Service Letter

Service Bulletin No. SL TMG 000-1003, Initial Issue
Date: December 13, 2016

Subject: Correct Installation of V-Belt

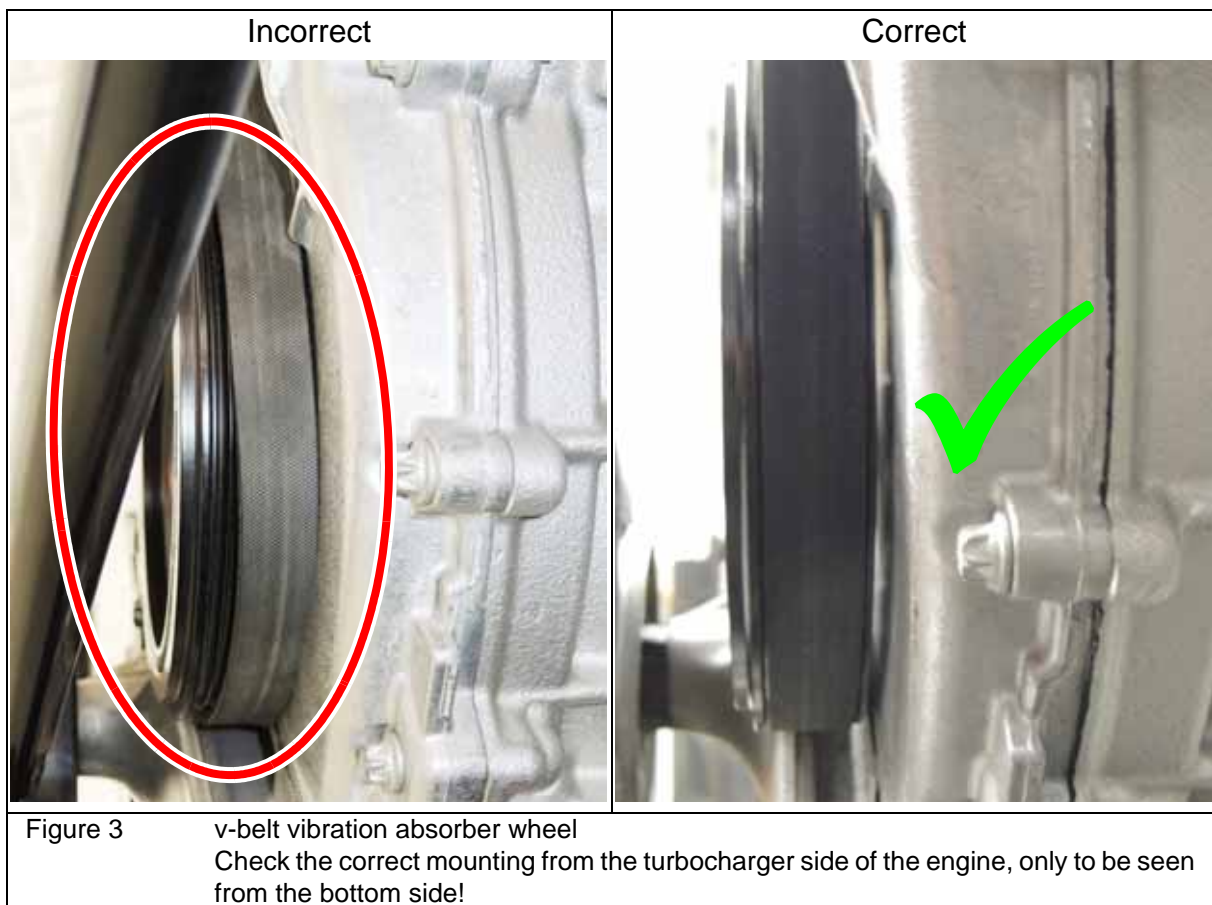
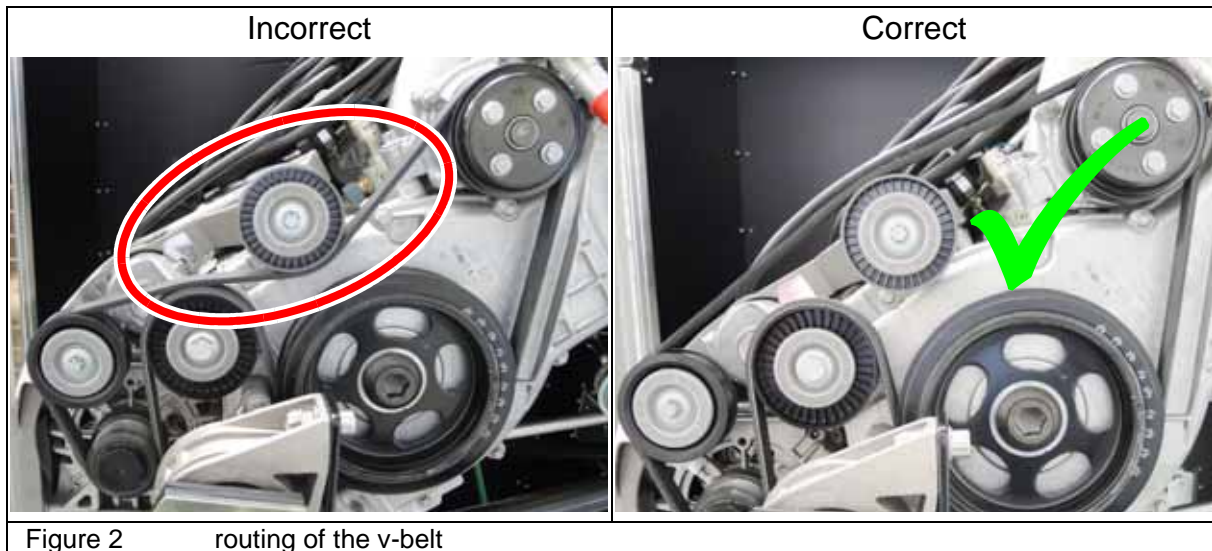
Reason: We have detected maintenance problems with some incorrect mounted v-belts. Risk of broken v-belt after incorrect installation. Further damages at the engine, coolant pump fail and engine overheating.

Following figures of incorrect and correct mounted v-belt to show what to check for:

An incorrect installed v-belt must be exchanged!
In accordance with RM-02-01 Chapter 07.0 / RM-02-02 Chapter 72-20.01.
